Project	IEEE 802.16 Broadband Wireless Access Working Group < http://ieee802.org/16 >	
Title	Flow charts for MS Initial Ranging with Non-transparent RS (Distributed)	
Date Submitted	2007-07-05	
Source(s)	Kanchei (Ken) Loa, Yi-Hsueh Tsai, Yung-Ting Lee, Hua-Chiang Yin, Shiann-Tsong Sheu, Youn-Tai Lee, Institute for Information Industry 8F, No. 218, Sec. 2, Dunhua S. Rd., Taipei City 106, Taiwan	Voice: +886-2-27399616 Fax: +886-2-23782328 loa@nmi.iii.org.tw
Re:	IEEE 802.16j-07/019: "Call for Technical Comments Regarding IEEE Project 802.16j"	
Abstract	This contribution proposes flow charts for MS Initial Ranging with Non-transparent RS	
Purpose	Text proposal for 802.16j Baseline Document.	
Notice	<i>This document does not represent the agreed views of the IEEE 802.16 Working Group or any of its subgroups. It represents only the views of the participants listed in the "Source(s)" field above. It is offered as a basis for discussion. It is not binding on the contributor(s), who reserve(s) the right to add, amend or withdraw material contained herein.</i>

Flow charts for MS Initial Ranging with Non-transparent RS (Distributed)

Introduction

Figure 95i Handle CDMA Initial Ranging Code at Non-transparent RS

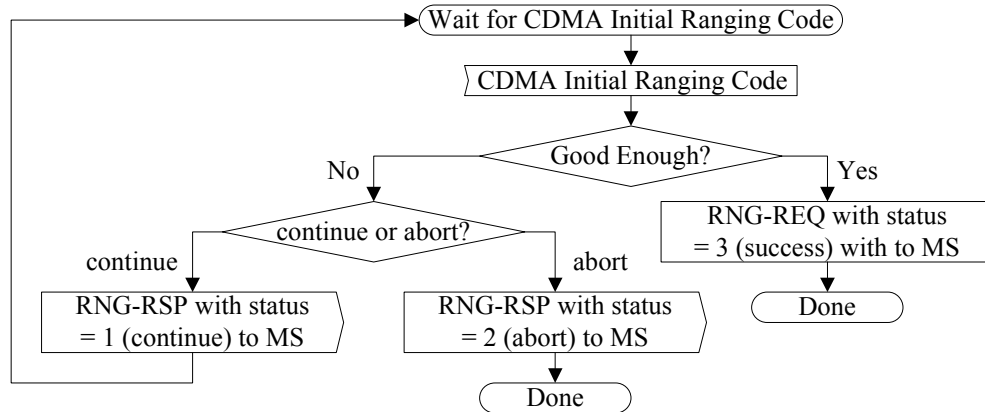
The message sequences charts (Table 199c and Table 199d) and flow charts (Figure 95i, Figure 95j, Figure 95k) on the following page defines the ranging and adjustment process that shall be followed by compliant RSs and MR-BSs. For CDMA ranging process between RS and MS, these details can be found in 6.3.10.3.

[Insert the following figures at the end of subclause 6.3.9.16.2.2:]
